**ATHERTON LIBRARY BUILDING PROJECT
ENVIRONMENTAL IMPACT REPORT
RESPONSE TO COMMENTS DOCUMENT**

STATE CLEARINGHOUSE NO. 2011112059

June 2012

LSA Associates, Inc.
2215 Fifth Street
Berkeley, CA 94710
510.540.7331

FIGURE IV.D-4 - REVISED

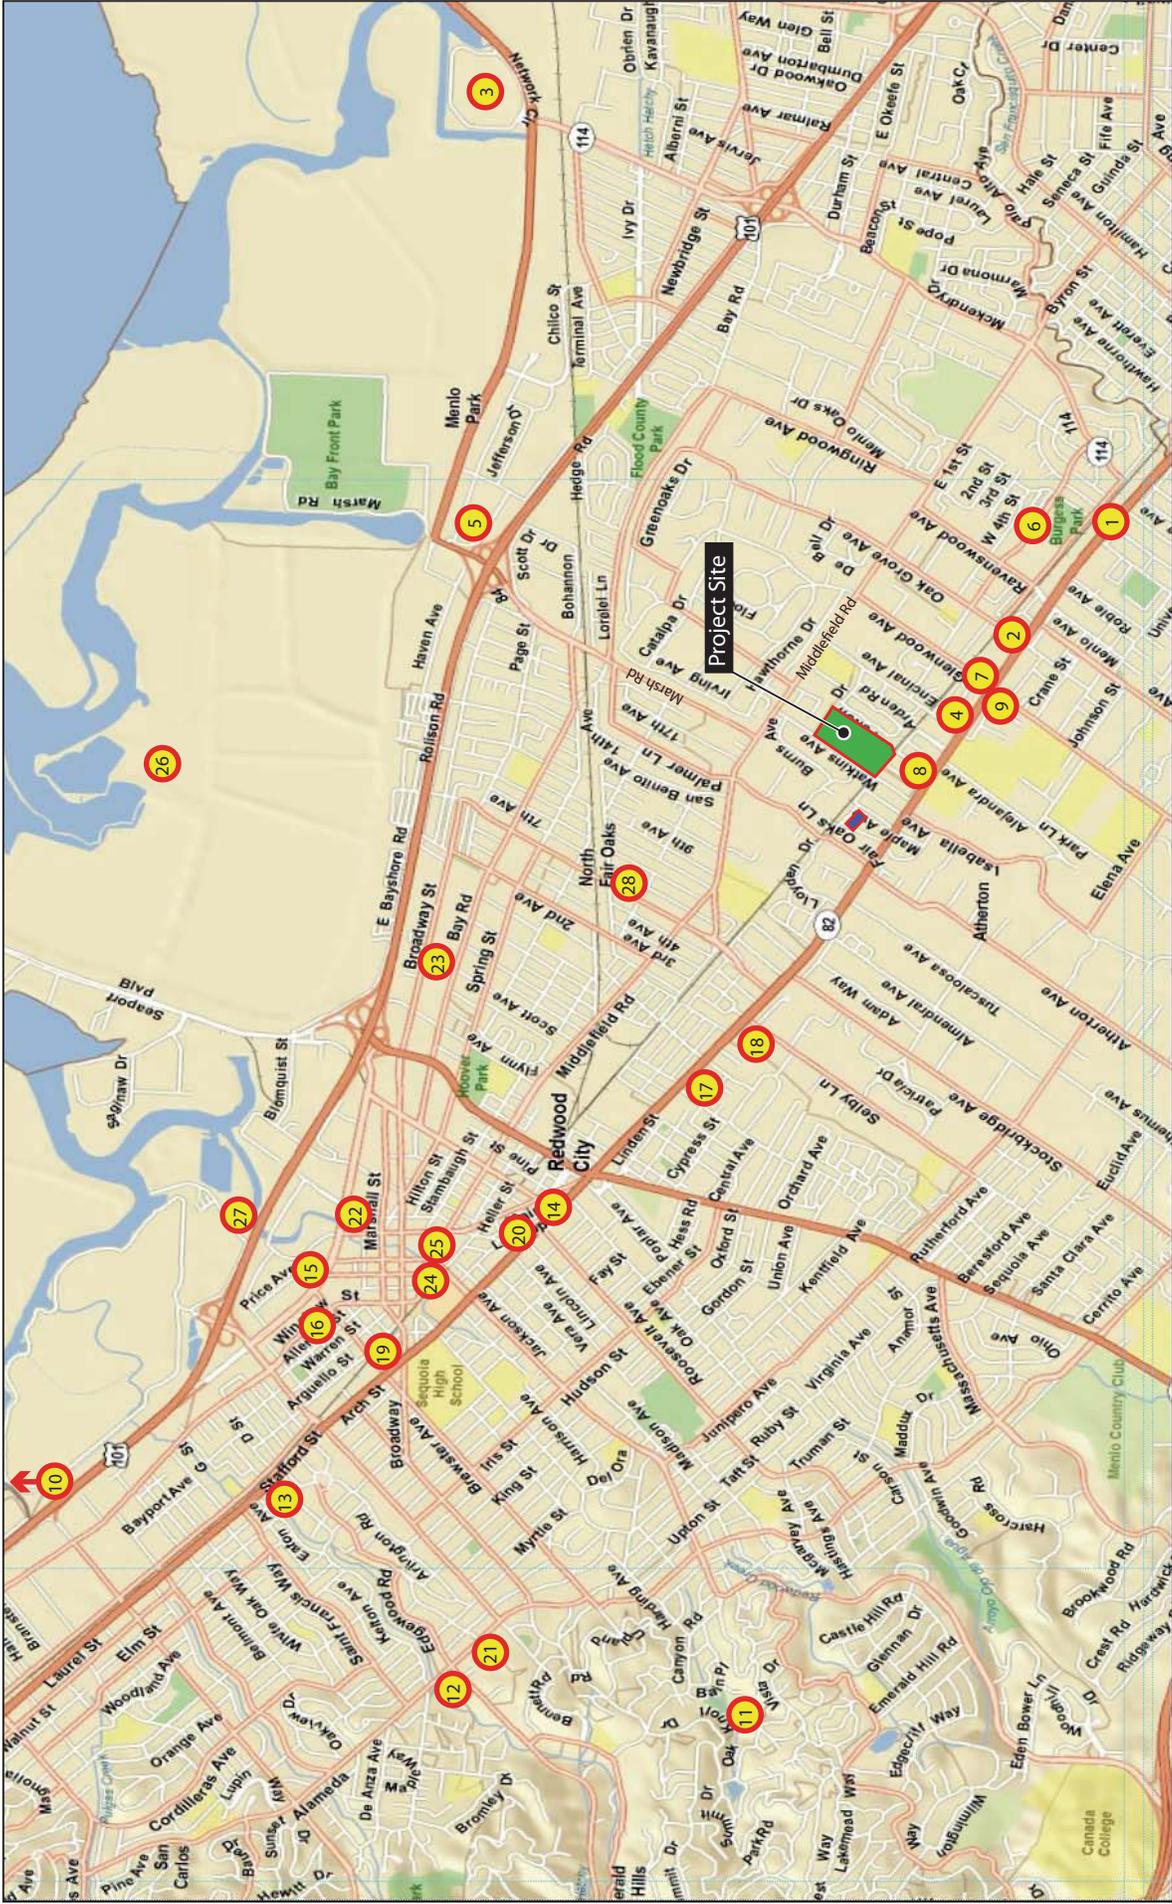
Pages 116 through 117 of the Draft EIR are revised as follows:

As noted in Chapter III, Project Description, the Main House would be demolished in order to construct the new library; therefore, private events would no longer occur at the site. However, the Pavilion, which has a capacity of 150 persons, and the meadows may continue to be available for private events after the construction of the library. Assuming an average vehicle occupancy of two persons per vehicle for a special event, up to 75 additional parking spaces could be required to accommodate such events. As noted in Table IV.D-22, there would be fewer than formal 75 parking spaces available at the park during weekday or weekend peak parking demand periods after construction of the library. Therefore, events occurring at the Pavilion could result in parking demands within the park that exceed the available supply.
